寄件者: Chong Hermose [REDACTED]
寄件日期: 2026 年 10 月 8 日 14:57
收件者: tpbpd/PLAND <tpbpd@pland.gov.hk>
副本: Jason Sek Hei WONG/PLAND <jshwong@pland.gov.hk>; Athena Pui Yin LAI/PLAND <apylai@pland.gov.hk>
主旨: S.16 Planning Application No. A/YL-SK/468 - 回應部門意見

Response to Comment From: Drainage Services Department (Mr. Jeff Tse) Received Date: 23 September 2026	
I.	According to our record, the size of the existing DSD's u-channel (SUP1028353) should be 300mm instead of 600mm. The applicant should check and ensure the hydraulic capacity of the existing drainage facilities would not be adversely affected by the captioned development.	According to the government open data on GEOINFO MAP and our site measurement shown in Appendix C, the SUP1028353 is 600mm. The hydraulic capacity of the existing drainage facilities is included in Appendix F. Please refer to below link: https://www.map.gov.hk/gm/s/dsd/SUP1028353
II.	According to Drawing No. 20250711b, it is noted that levelling works will be carried out under this application. Please be reminded that peripheral surface channels shall be provided along the site boundary at the existing/original ground level (instead of the revised ground level) t

Appendix C
Location Plan and Photos of the Existing Drainage

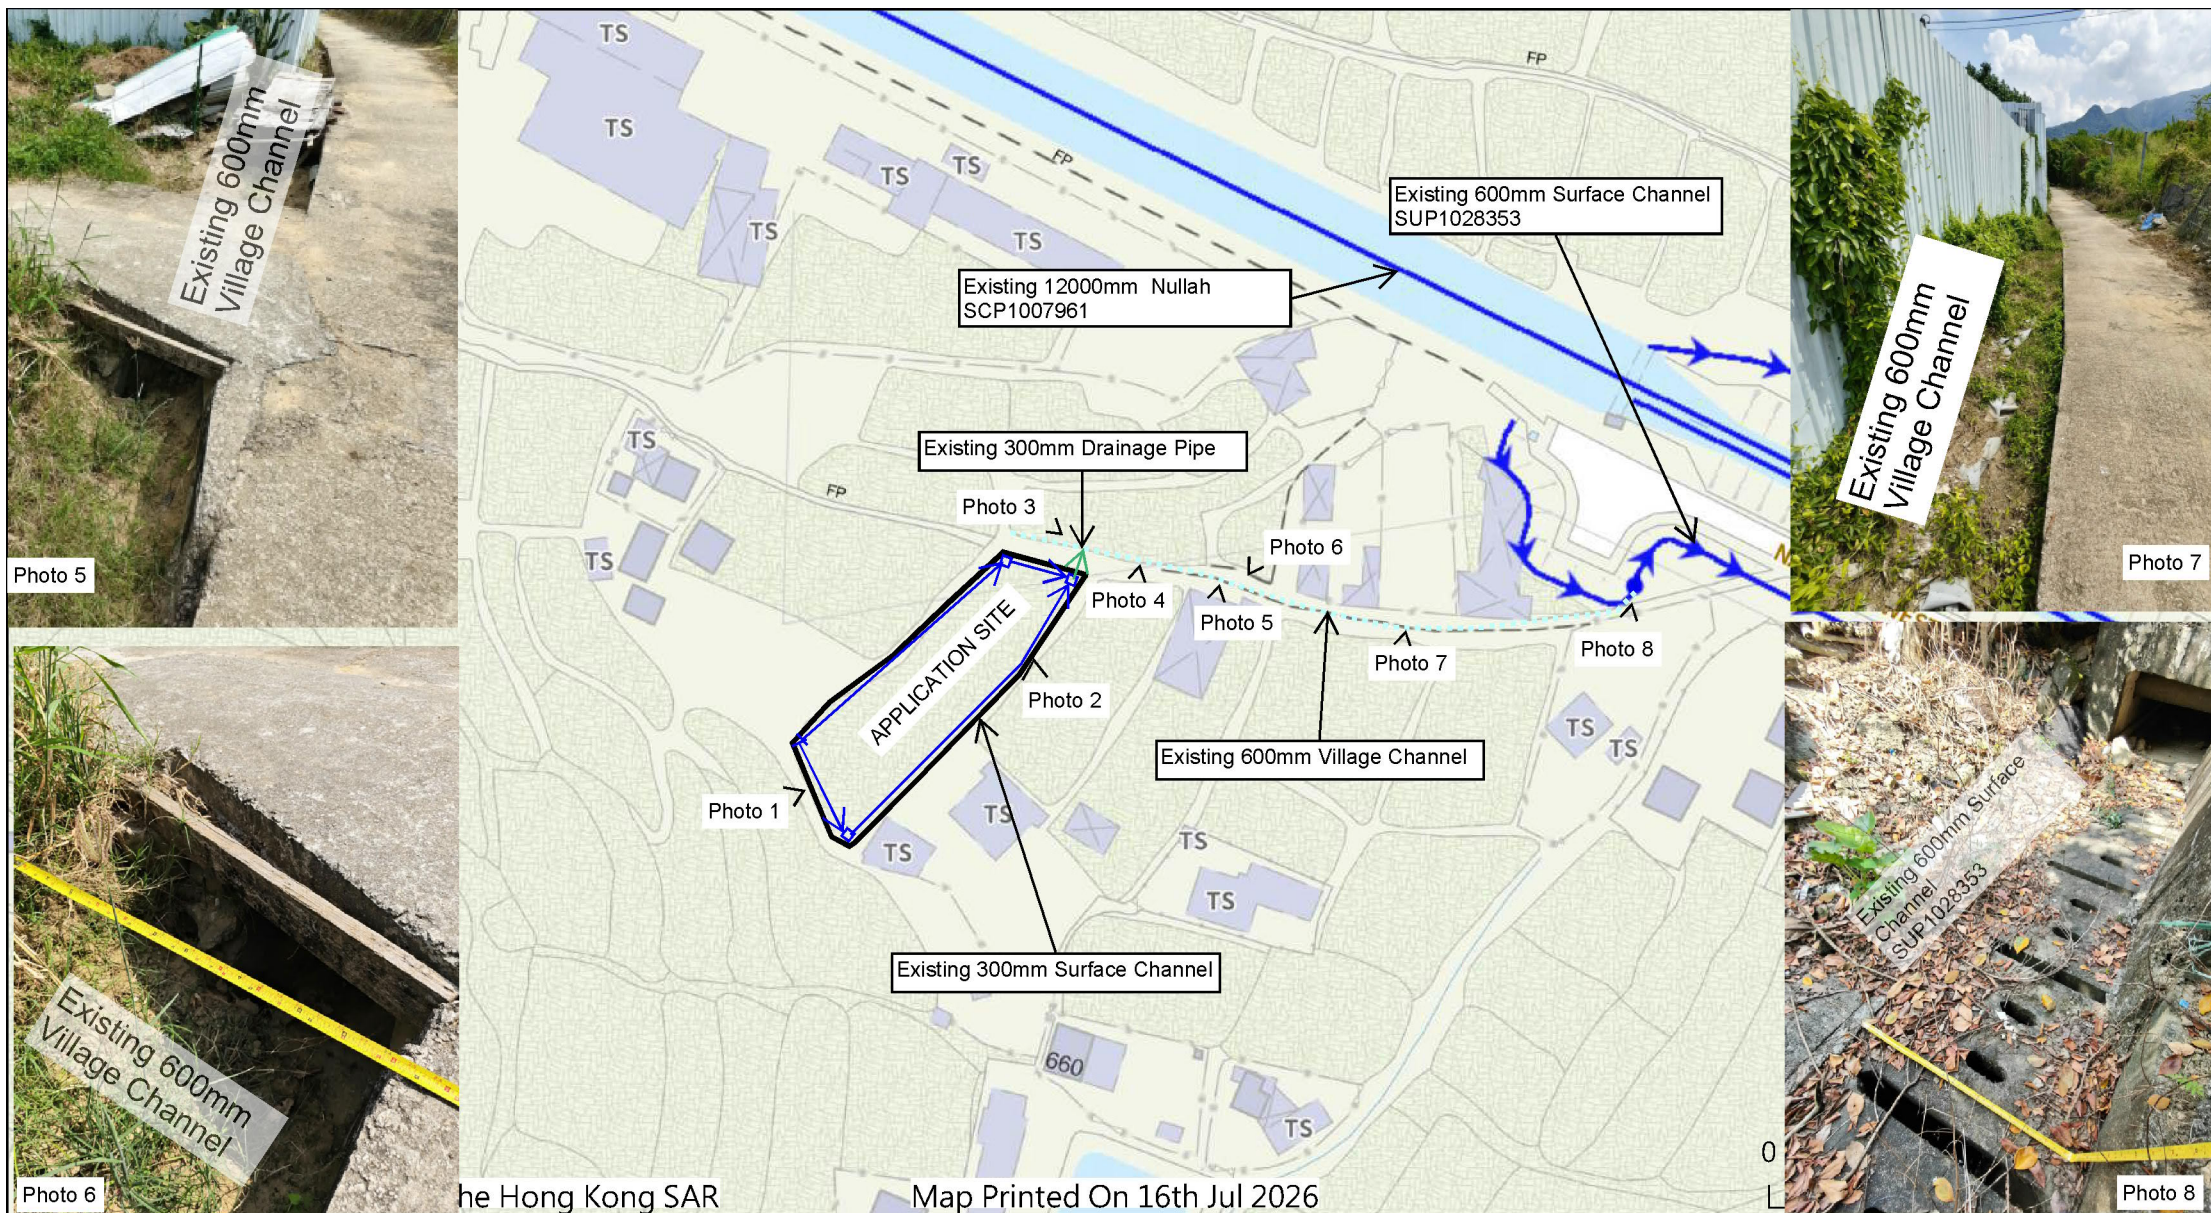
shall resolve any conflict/disagreement arisen for discharging the runoff from the application site(s) to the proposed discharge point(s). In the case that it is a local village drains, DO/YL should be consulted. Moreover, the applicant(s) should ensure that this drainage system and the existing downstream drains/channels/streams have adequate capacity to convey the additional runoff from the application site(s). Regular maintenance should be carried out by the applicant(s) to avoid blockage of the system.	
VIII.	Further to (vii) above, since there is no record of the said discharge path, please provide site photos at different locations and views to demonstrate its presence and existing condition (especially the location between Photos 3 and 4 taken, etc.). In addition, according to Photo 3, it cannot clearly indicate the condition of the existing 600mm u-channel. Please review	Noted and Appendix C is updated with more photos. Vegetation will be cleared and maintained.
